AIRPORT LAND USE COMMITTEE (ALUC)

AGENDA

Date: Thursday, October 27, 2016

SUBJECT: Review and recommend approval of a determination of conditional consistency for the City of San Carlos, Hilton Garden Inn Project with the Airport Land Use Compatibility Plan for the Environs of San Carlos Airport

EXTERIOR ELEVATIONS

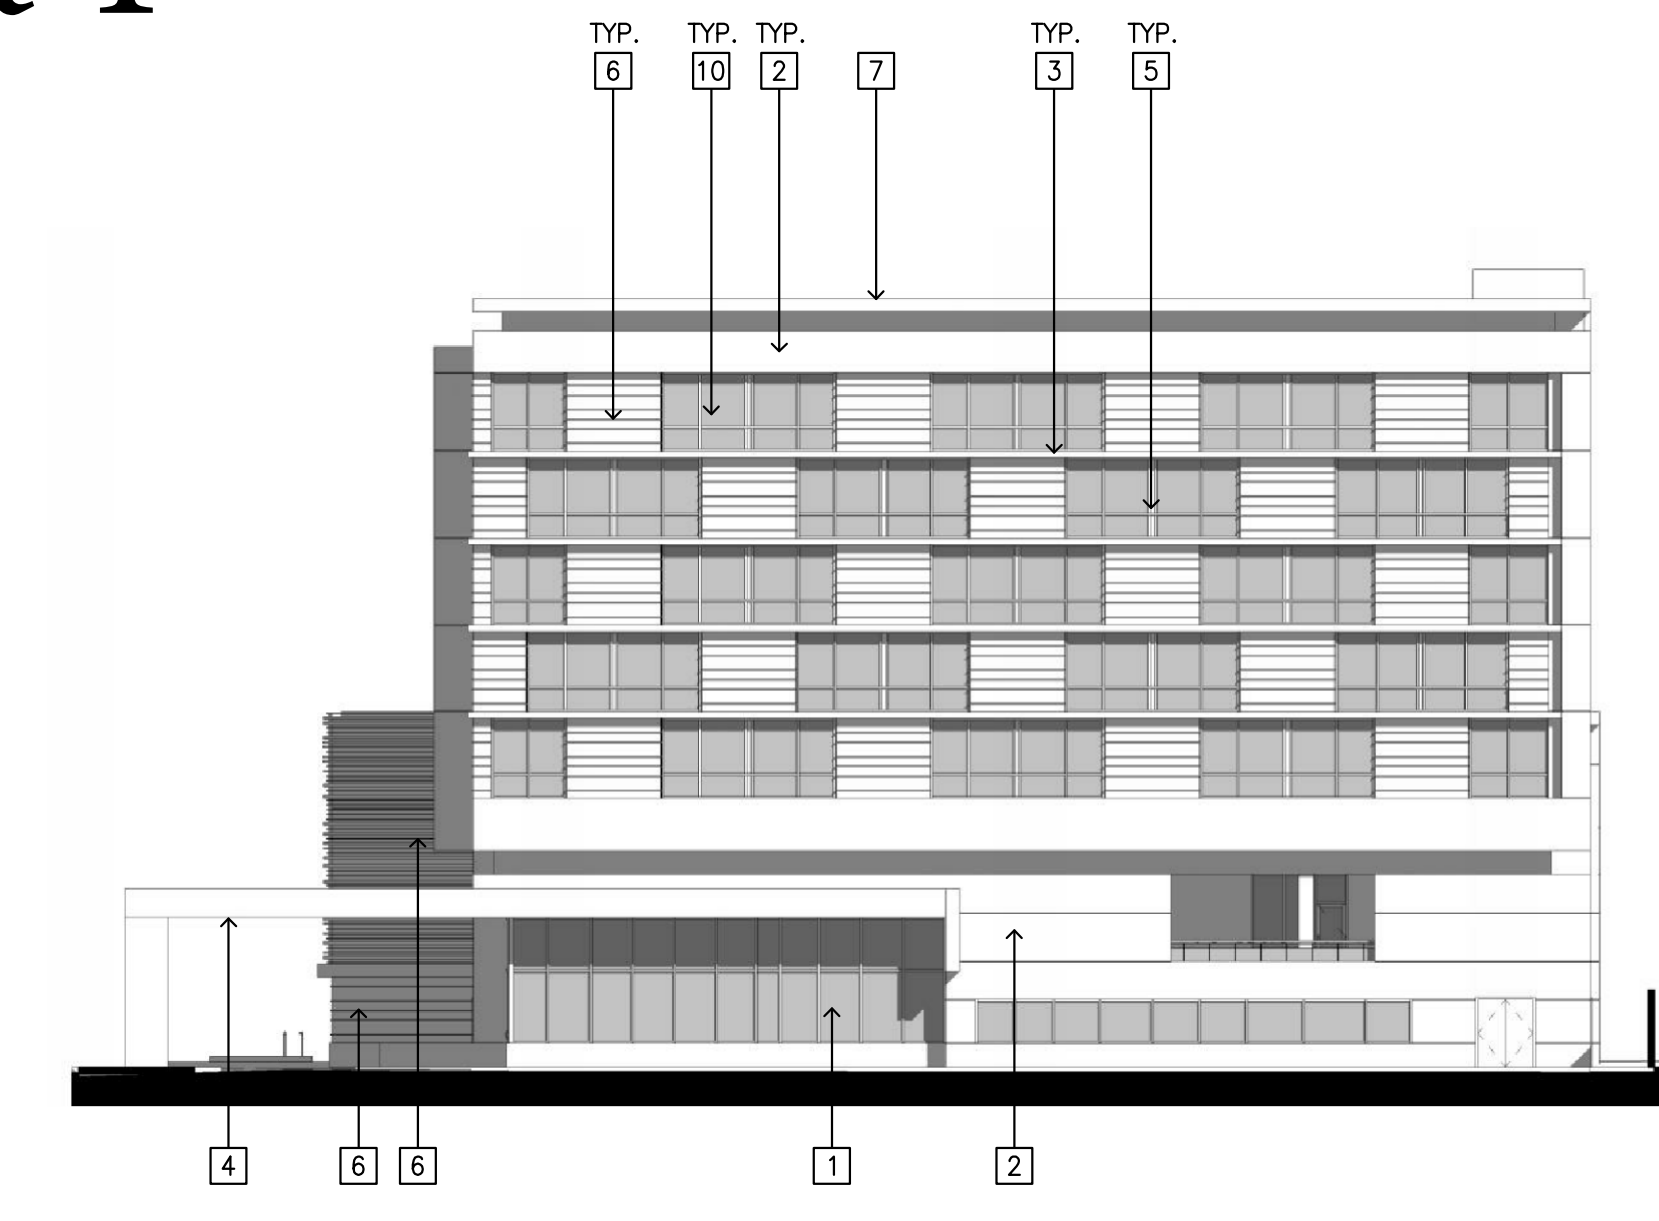
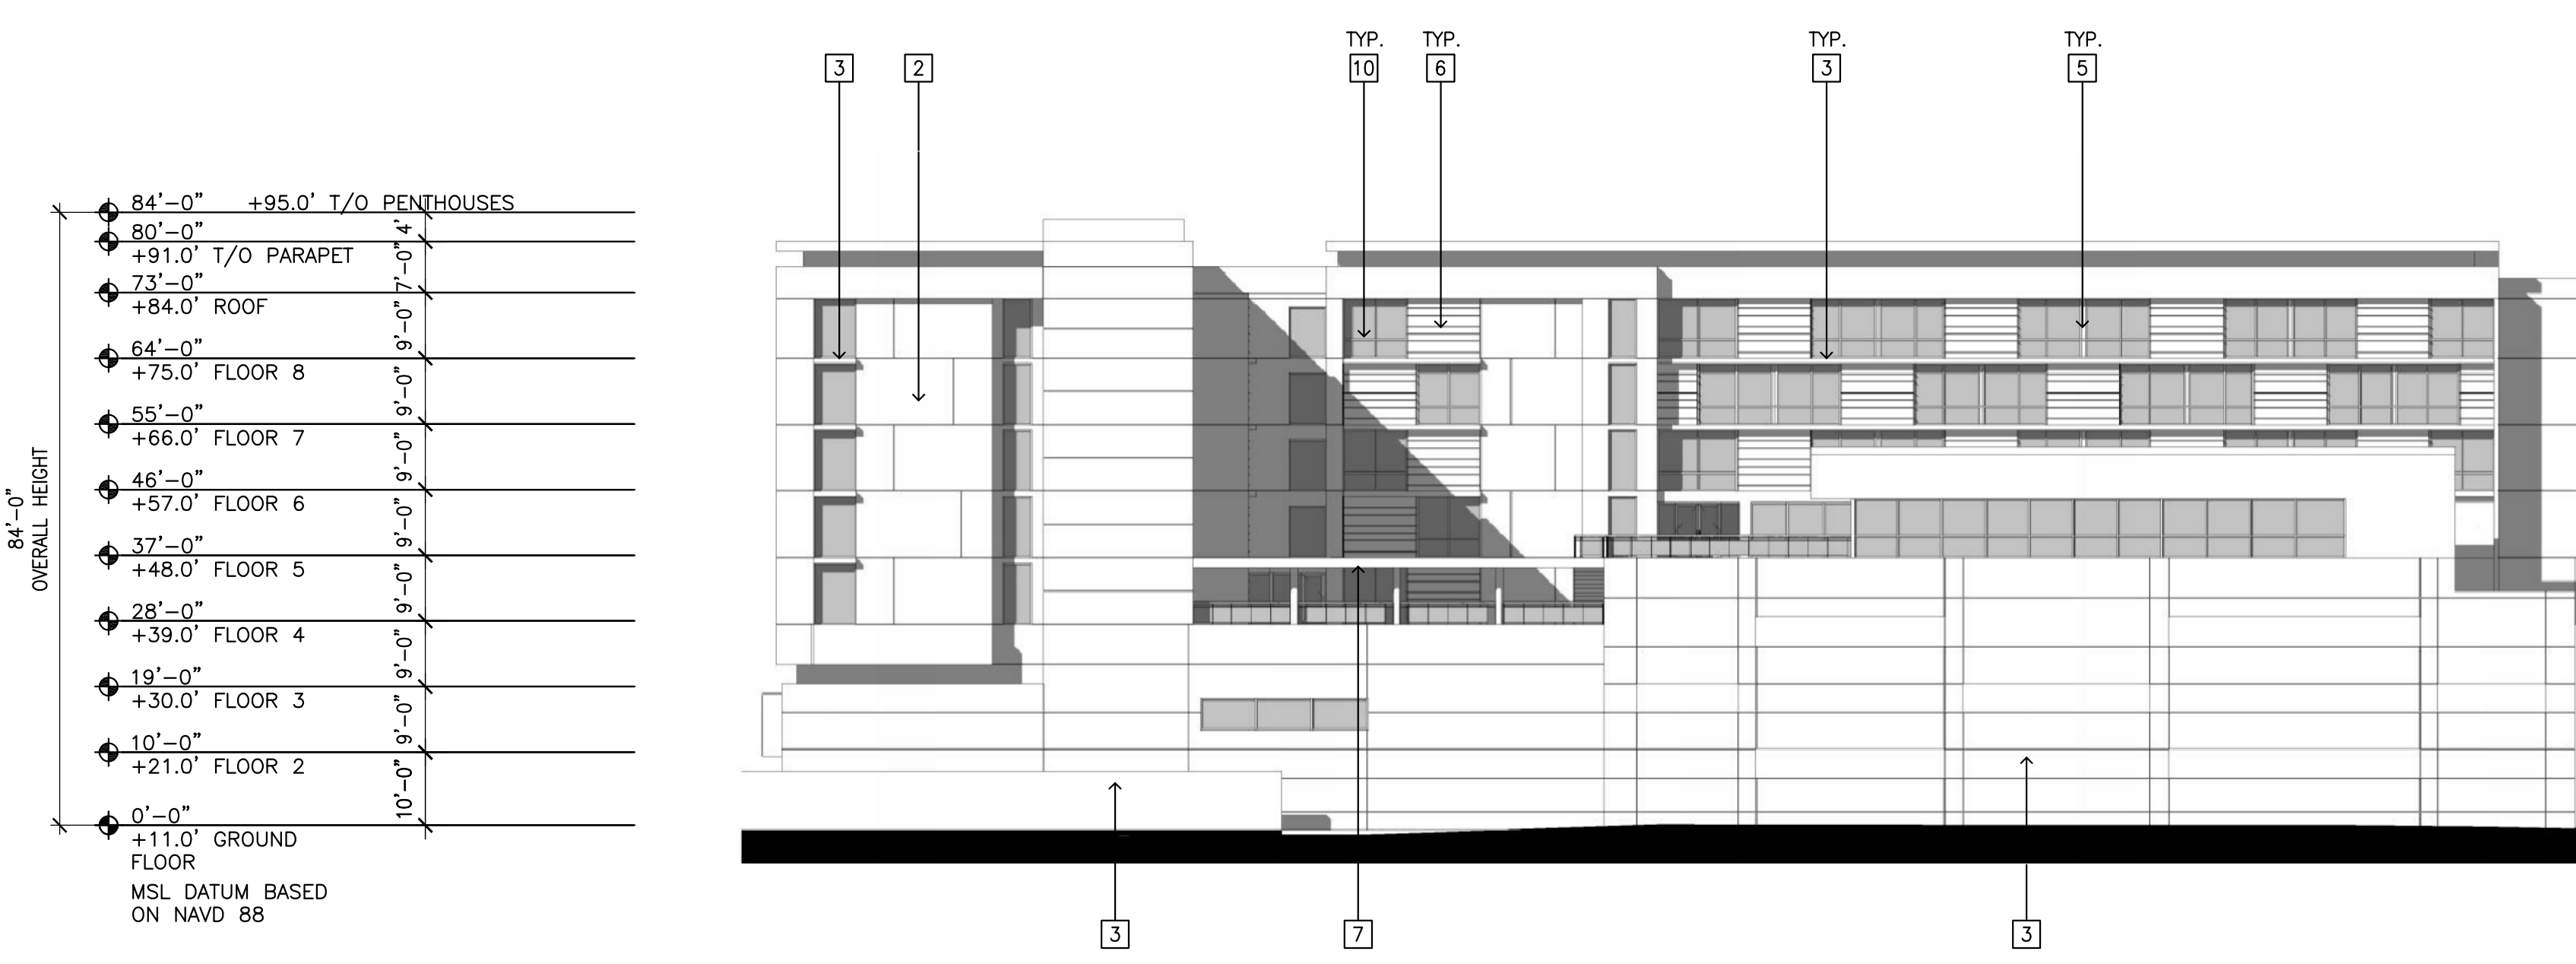
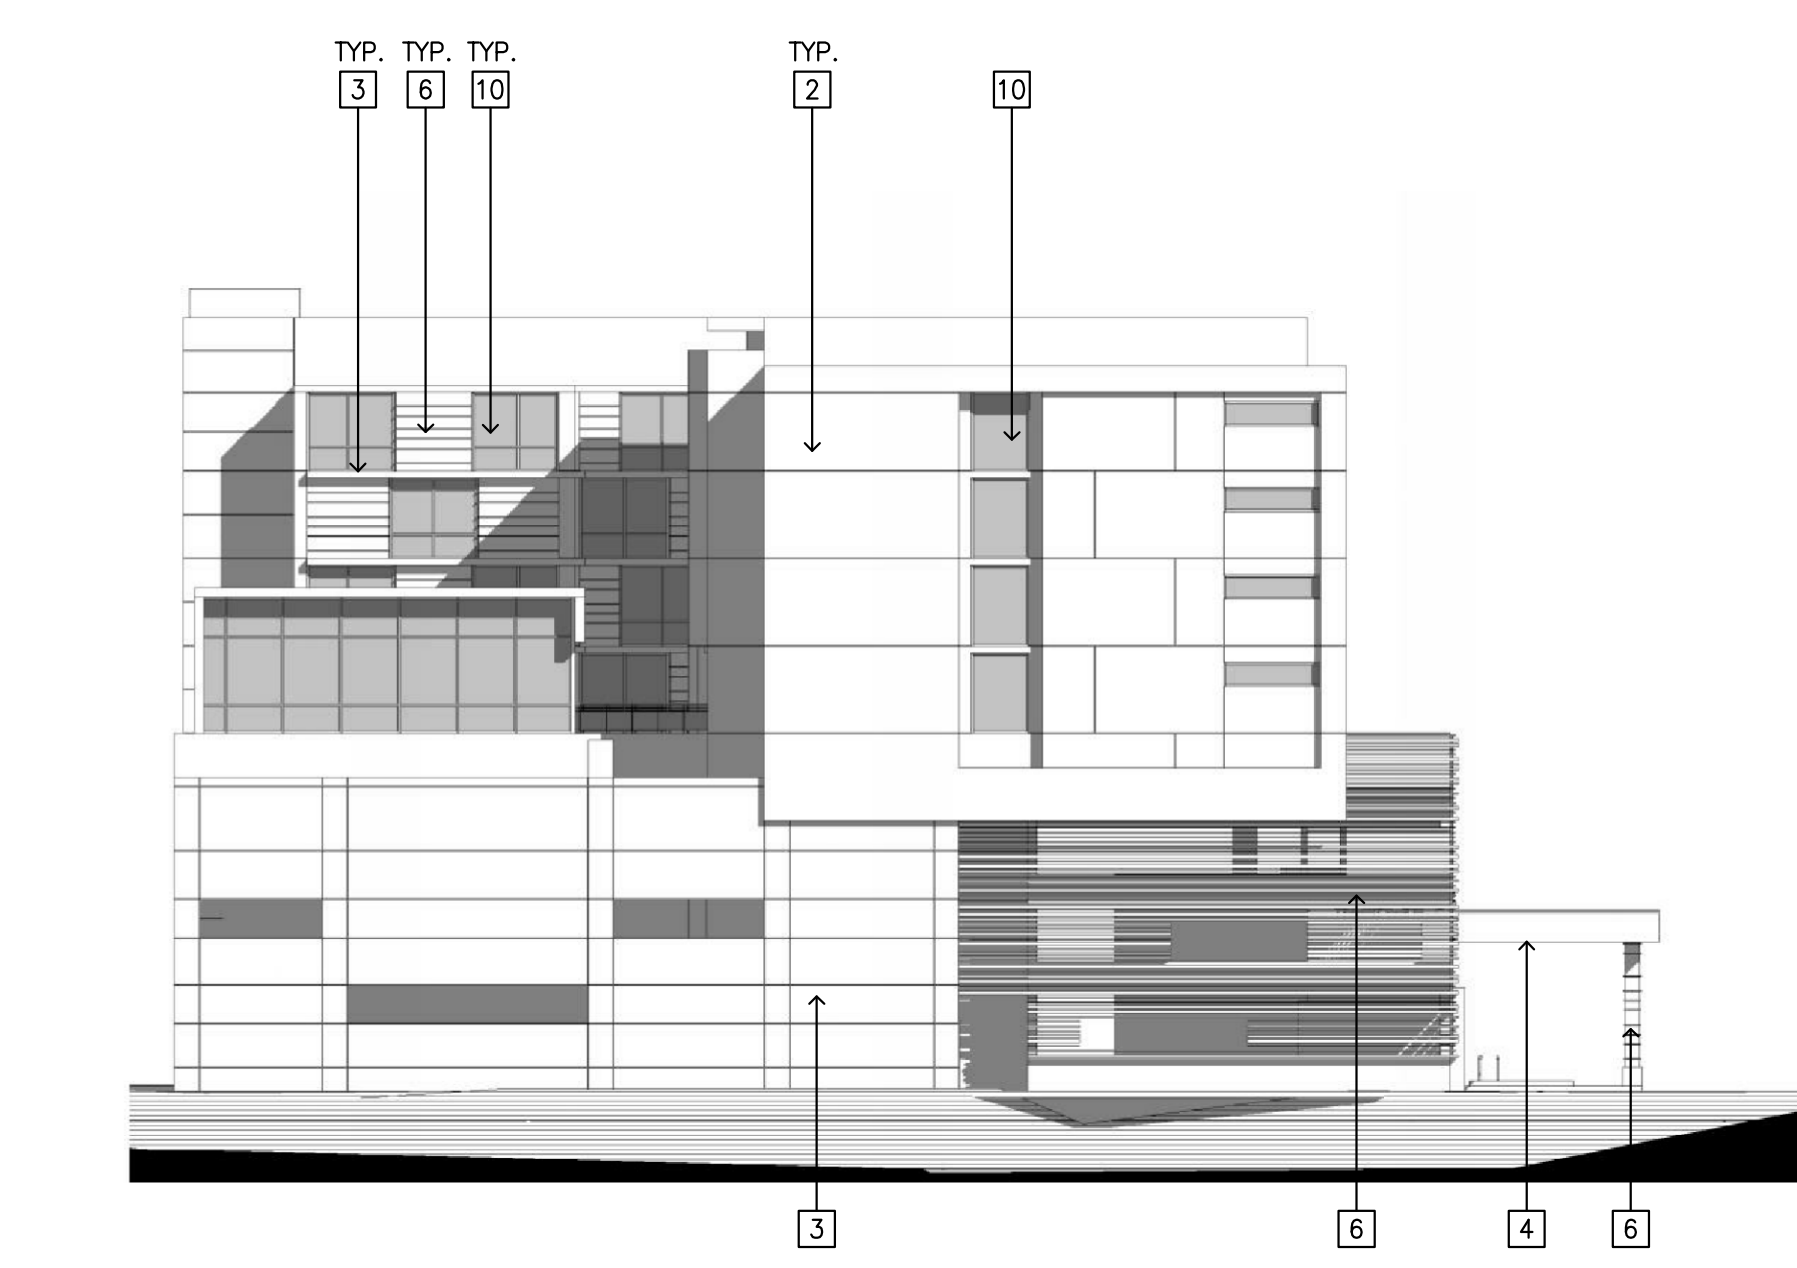
The City of San Carlos is located inside of the 14 CFR Part 77 horizontal, conical, primary, approach and transitional imaginary surface contours. The parcel for the Hilton Garden Inn Project is located within the horizontal surface contour. The height for the imaginary surface established for the horizontal surface at the site location is 155 feet above mean sea level. The project parcel is located at 11 feet above mean sea level. The hotel is designed to be constructed at a maximum building height of 84' above ground level. Therefore, the structure being built at a maximum of 95' above mean sea level will be well below the imaginary surface height established.

Highest point of structure above mean sea level	Height of structure compared to the imaginary surface of approximately 155 feet above mean sea level
95 feet	Highest point of structure will be approximately 60 feet below the imaginary surface.

Airspace Protection Policy 5 in the SQL ALUCP states that the lower of the two shall apply when considering both the imaginary surface heights established in the ALUCP and those established by a determination from the FAA. The FAA determinations are included as attachments to this staff report. The project will be required to be built at the heights, or lower, as described in the attached FAA Determinations of No Hazard to Air Navigation to remain consistent with Airspace Protection Policy 5.

Airspace Protection Policy 6 provides that lands uses that may cause visual, electronic, navigational, or wildlife hazards, particularly bird strike hazards, to aircraft in flight or taking off or landing at San Carlos Airport are incompatible in Area B of the Airport Influence Area in which the project site lies. The project is conditionally consistent with airspace protection policy 6 and shall comply with this policy in order to be found fully consistent.

- The Hilton Garden Inn project shall comply with the height limits as defined in the 6 Federal Aviation Administration (FAA) “Determination of No Hazard to Air Navigation” reports included as Attachment 2.
- The Hilton Garden Inn project shall comply with Airspace Protection Policy 6 of the SQL ALUCP.
